Agenda Item # 1

SUB-003868-2026

PL Russell Subdivision

- Subdivision approval to create two (2) legal lots of record from one (1) metes-and-bounds parcel.

SITE PLAN

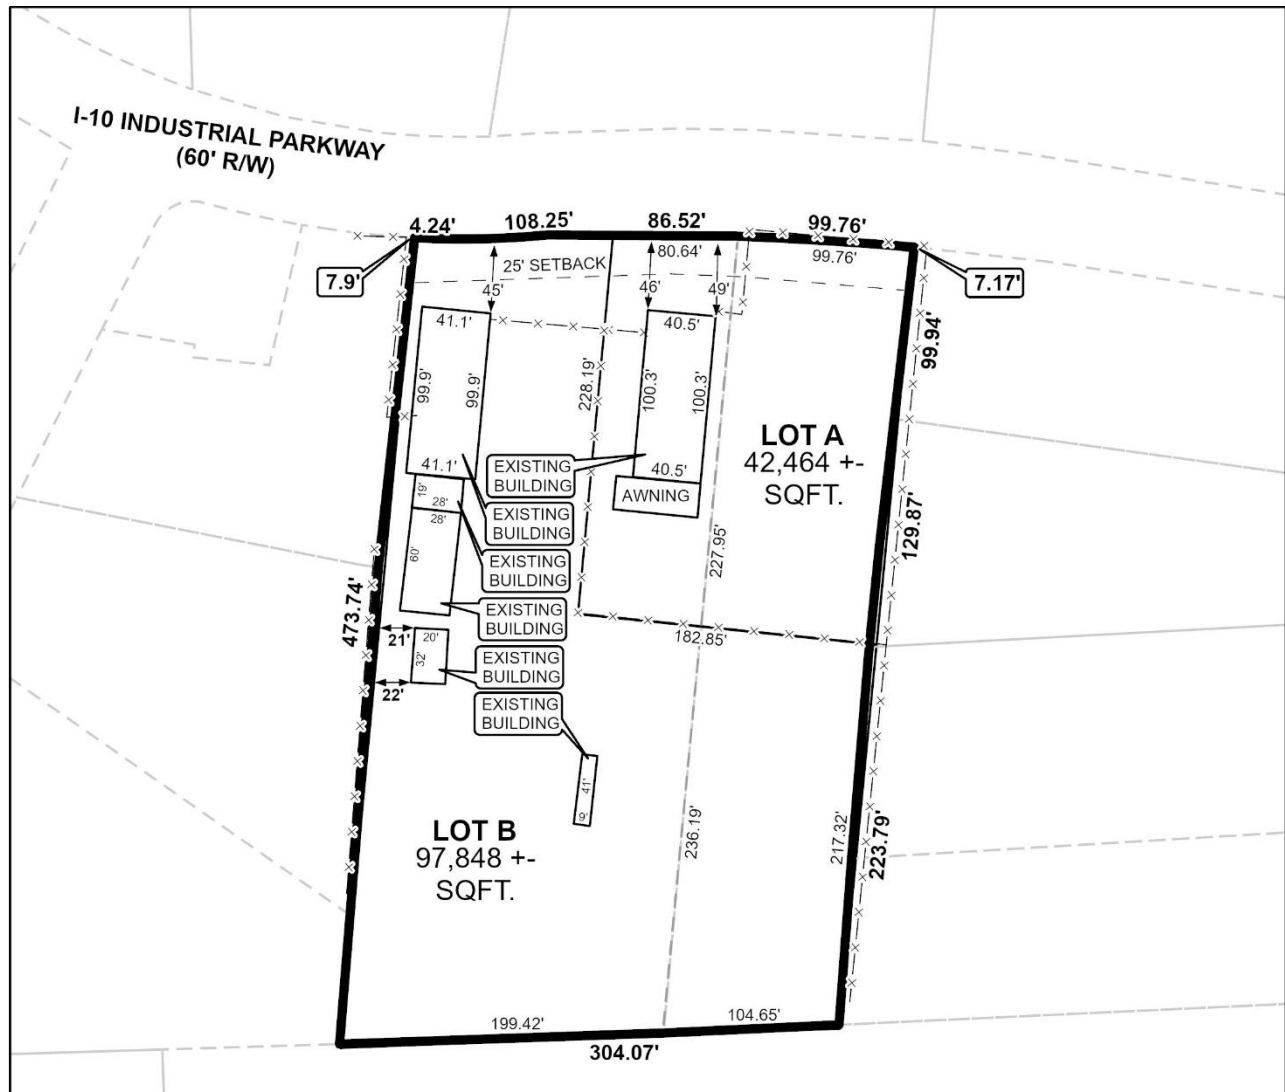
- B. Clarify the POB – is it the CRF or the CTF?
- C. Revise NOTES #7 to read - As shown on the aerial photos LOTS A & B share the 16,000 sf of historical credit of existing (1984) impervious area towards stormwater detention requirement per Mobile City Code, Chapter 17, Storm Water Management and Flood Control) as follows: LOT A – 8,500 sf and LOT B – 7,500 sf. Stormwater detention will be required for any additional impervious area that exceeds the allowable credit for that LOT.

- E. Retain NOTES #1 - #5.
- F. Email a pdf copy of the FINAL SUBDIVISION PLAT and LETTER OF DECISION to the Permitting Engineering Dept. for review at land.disturbance@cityofmobile.gov prior to obtaining any signatures. No signatures are required on the drawing.

The proposed lots have frontage along I-10 Industrial Parkway, a minor street without curb and gutter that requires a 60-foot-wide right-of-way at this location. The preliminary plat illustrates the required right-of-way width; therefore, no additional dedication is necessary. This information should be retained on the Final Plat, if approved.

The proposed lots meet the minimum lot width requirements of Section 6.C.2.(b)(4) of the Subdivision Regulations for lots in Commercial Districts. The lots also exceed the minimum lot area requirements of Article 2, Section 64-2-14.E. of the Unified Development Code (UDC) for lots served by public water and sanitary sewer within a B-3, Community Business Suburban District. No minimum lot area is required for lots within the I-1, Light Industry District. The proposed lots are labeled with their areas in both square feet and acres on the preliminary plat. If approved, this information should be retained on the Final Plat, or a table providing the same information may be included.

The preliminary plat illustrates a 25-foot front yard setback along I-10 Industrial Parkway, in accordance with Article 2, Section 64-2-21.E. of the UDC and Section 6.C.8. of the Subdivision Regulations. If approved, this setback should be retained on the Final Plat.

As proposed, Lot B may be considered a flag-shaped lot. Section 6.C.9. of the Subdivision Regulations generally discourages flag-shaped lots, except in unusual circumstances or in areas where varied and irregular lot configurations are common. Although the proposed configuration is non-standard, similarly shaped lots appear to be present in the surrounding area and are utilized for industrial purposes. Therefore, a waiver of Section 6.C.9. of the Subdivision Regulations may be appropriate.

As submitted, approval of the subdivision would result in both proposed lots being split-zoned between B-3, Community Business Suburban District, and I-1, Light Industry District. The applicant has also submitted a request to rezone the property. Article 5, Section 64-5-1.D. of the UDC requires applications related to the same site to be filed and heard concurrently. Therefore, a holdover of the Subdivision application would be appropriate to allow the subdivision and rezoning requests to be considered concurrently.
